Recall Bulletin

FMVSS NONCOMPLIANCE RECALL

SUBJECT: Fuel Label Compliance

MODELS: 2013-2014 Chevrolet Express, Silverado HD
2013 GMC Savana
2013-2014 GMC Sierra HD
Compressed Natural Gas Vehicles

Chevrolet Express/GMC Savana Label Installation Instructions

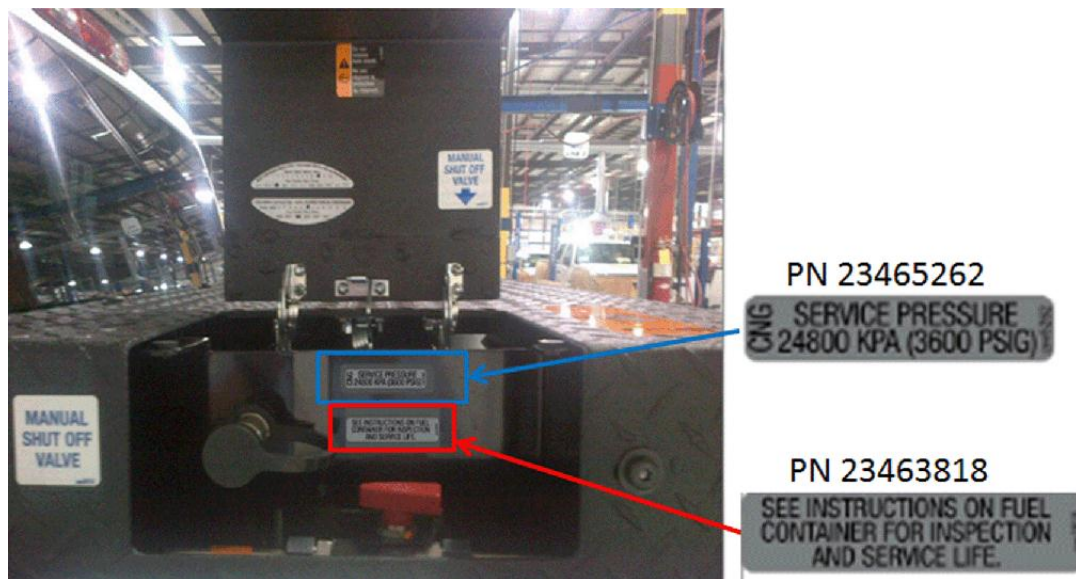
Dealers are to remove the label on the inside of the fuel door and install two new labels that contain larger print.

1. Remove existing label and any residue using isopropyl alcohol. Dry the label surface with clean, lint free cloth. The label surface must be clean, dry and free of any contaminants. Do NOT place new label over an existing label.
2. Firmly hold the new label and peel protective liner from the back side, being careful not to touch or contaminate the adhesive with dirt or foreign matter.
3. Carefully align new label to the surface press firmly and smooth out entire label ensuring corners are fully adhered.
